# Service Bulletin

Bulletin No.: 09-08-42-005D

**Subject:** Driver/Passenger Door and/or IP Accent Lighting – Light Bar (Pipe) Inoperative or Loses Intensity

**Models:** 2010-2014 Chevrolet Camaro  
Equipped with Light Piped Door Trim (RPO FCR)

2294397

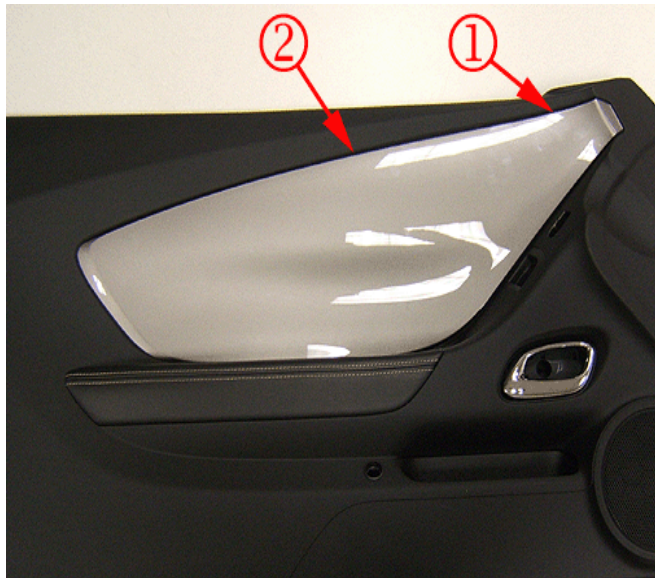
The normal operation of the door accent lighting is the light will be brightest at the rear of the door panel and gradually lose intensity until approximately 76 mm (3 in) (1) from the front edge of the trim panel. The lighting does not carry on to or across the instrument panel. If the light stops at the center of the door (2), proceed with this bulletin.

2294398

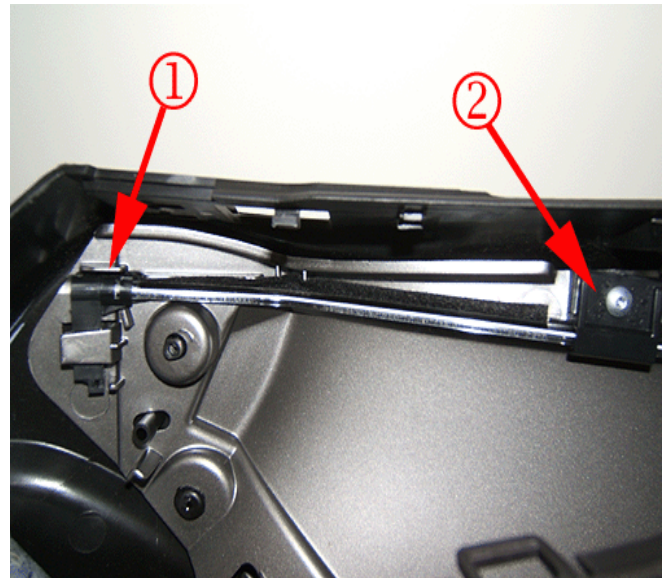
If the light stops at the center of the door, remove the trim panel and make sure the light bar (pipe):

1. Is in the channel
2. Has not dipped down
3. Is properly retained by the retaining clips (2)
4. End cap (1) is properly installed

To verify normal operation, apply 12 volts to the connector and make sure the light is brightest at the rear of the panel and gradually dims towards the front of the door panel.

If the light bar (pipe) is not illuminated the full length, is noticeably different from side to side or inoperative, replace the lamp-harness assembly. There are two different part numbers based on the illumination color of the lamp.
